Town of Hilton Head Island

Design Review Board Meeting

Below are modifications from the previous submittal for 2 Lafayette Place, originally reviewed on the 11/25 DRB meeting.

**Chase Bank
2 Lafayette Place
Plan Set
December 23, 2025
DRB-001104-2025**

SHEET TITLE:
SITE PLAN
SHEET NUMBER:
C-301
ORG. DATE - #####

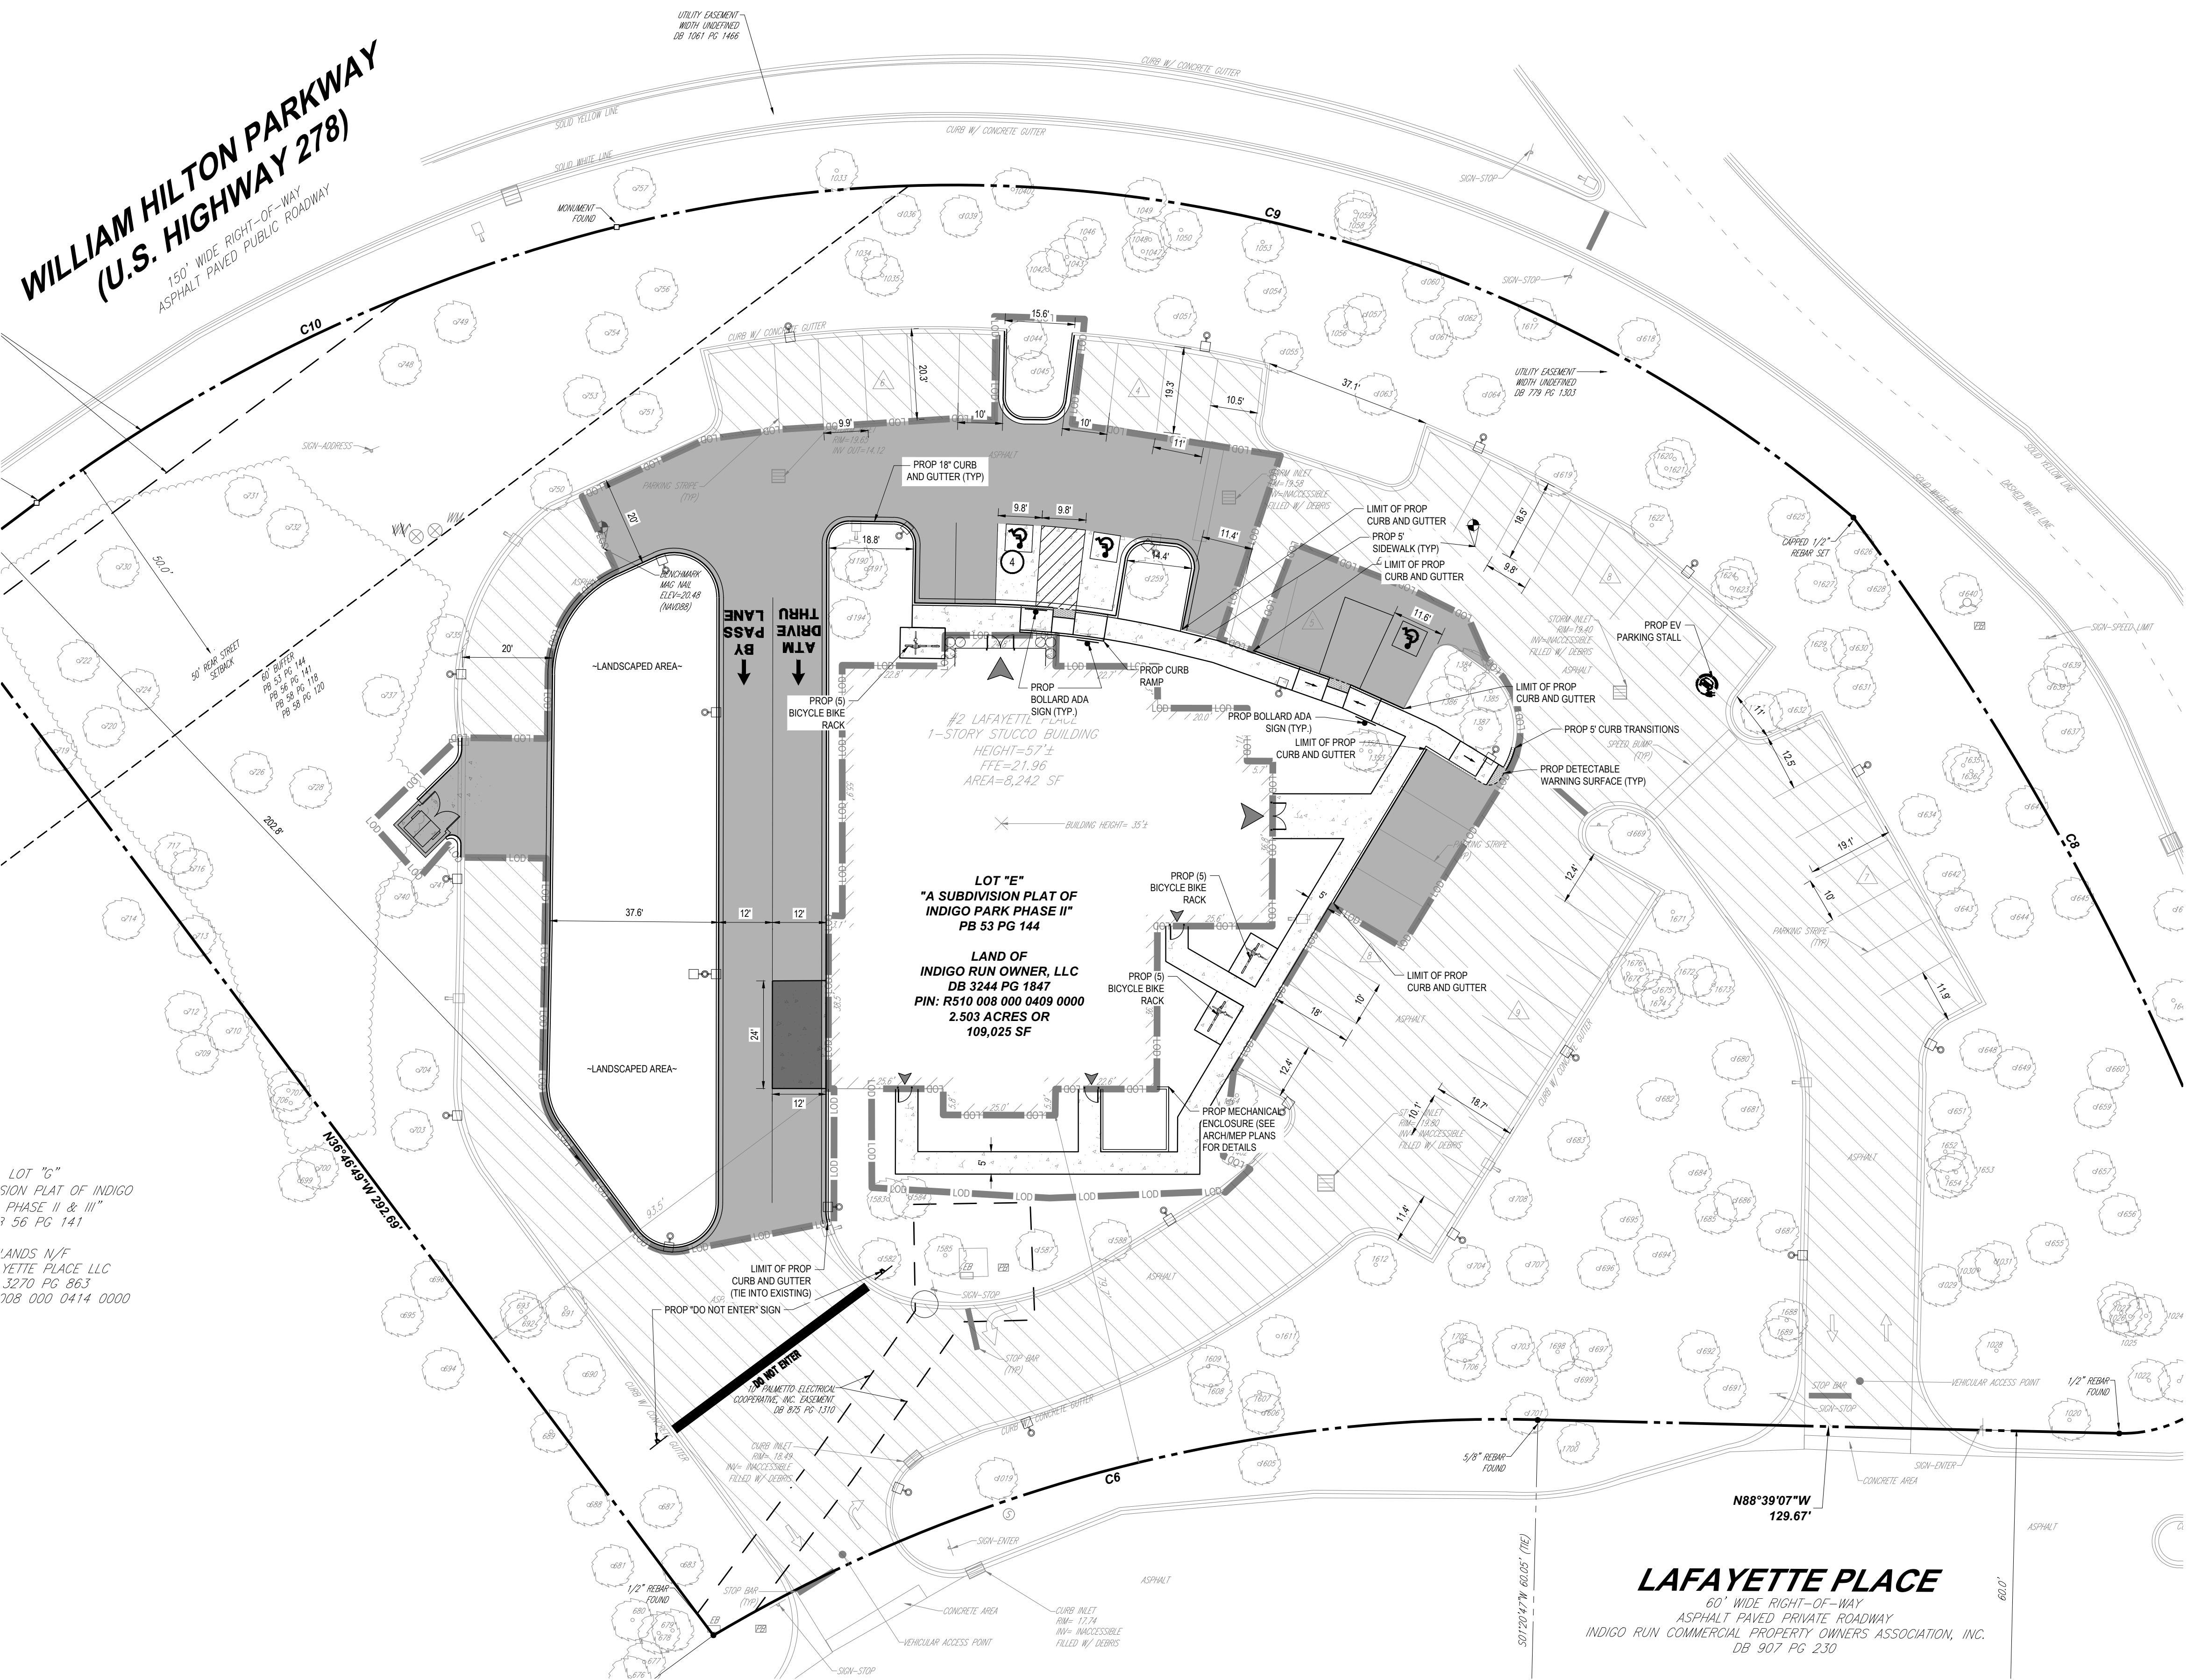
Site Plan – An additional ADA parking stall, EV parking stall, and Bike Racks have been added.
